Miscellaneous Correspondence Relating
Primarily to Building Construction
Alterations & Inspections, 1935-1937.

Denver, Colo. U.S. Mint,

In reference to the contract with the F.J. Kirchoff Construction Co., for the Re-modeling and Extention of the U.S. Mint, Denver, Colo.

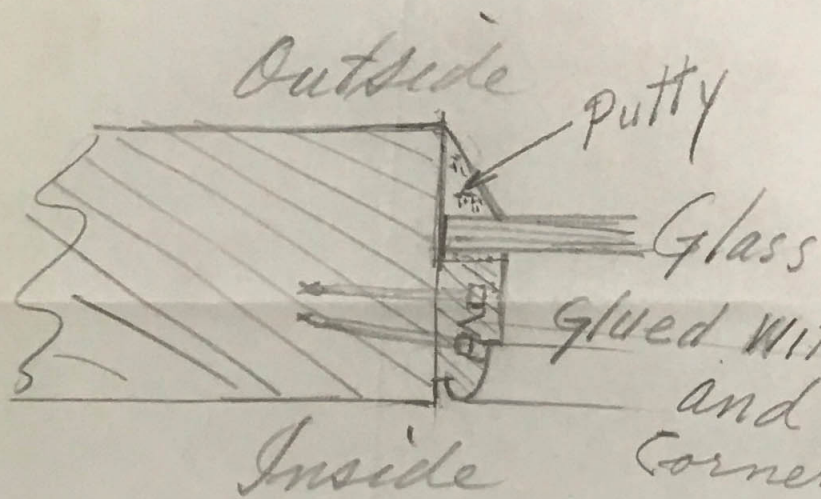
Attention is called to the plans and specifications in connection with the first story windows in the extended part not being similar to the existing first floor frames in the old building.

Contract plans, elevations and scale drawings indicate window frames for the first and second floors with two mullions and having a swinging in transom sash.

Side notes on elevation No.1-100 and scale drawings No.1-200 and 1-201 requires that, "All windows including cover moulds to be wood instead of metal as shown on drawings, see specifications" This note in changing frames from metal to wood made no mention of change in design for either story.

Full Size Drawing No.502 as furnished contractor, details windows for the second floor with mullion frames. This drawing and supplement drawing No.504, as furnished, did not detail or make any mention of mullions frames for the first story windows.

However, drawing No.502- carries a note at the bottom, that, "All first floor windows to be similar to existing first floor windows; while the contract plans and scale drawings plainly requires double mullion frames for the first floor."

Now that the existing window frames in the first story of the old building have no mullions and that the transom sash in same is fixed; the question arises as to what to provide for the first story of the Extension.

Please advise by wire if note on F.Size No.502 is intended to supersede contract drawings and that if first story frames are to be similar in design to old frames or merely to be similar in detail and construction.

YOURS FEBRUARY 28, RELATIVE 1ST FLOOR WINDOWS, DENVER MINT, FULL SIZE DETAILS
502 SHOW CONSTRUCTION BASEMENT AND 2ND FLOOR WINDOWS. STOP, 1ST FLOOR WINDOWS
TO BE AS SHOWN ON CONTRACT DRAWING MATCHING EXISTING WINDOWS FOR PROFILES.
• MILLIONS ADDED AS SHOWN ON CONTRACT DRAWING.

Yours February twentyeighth relative first floor windows
Denver Mint full size detail five hundred two shows
construction basement and second floor windows STOP First
floor windows to be as shown on contract drawings matching
existing windows for profiles but with mullions added as
shown on contract drawings.
